Release 2

AHI NOZZLE REPLACEMENT

Prevost vehicles

DESCRIPTION

Figure 5: Dozer

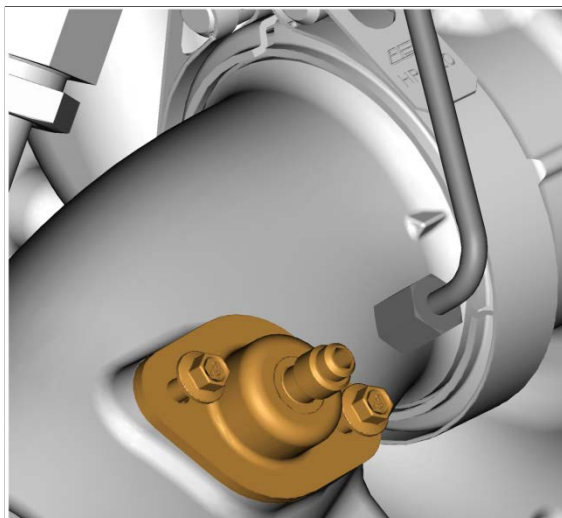
On the vehicles affected by this bulletin, replace the AHI dozer by an improved part preventing nozzle clogging.

7. Loosen the aftertreatment hydrocarbon dozer mounting fasteners. Remove the aftertreatment hydrocarbon dozer from the diffuser pipe (which attaches to the turbocharger outlet).
8. Clean the sealing surface on the diffuser pipe before mounting the aftertreatment hydrocarbon dozer.
9. Install a new gasket and aftertreatment hydrocarbon dozer onto the diffuser pipe.

Tighten to **125 ± 4.5 in-lb**

Note: The fasteners include pre-applied high-temperature anti-seize compound.
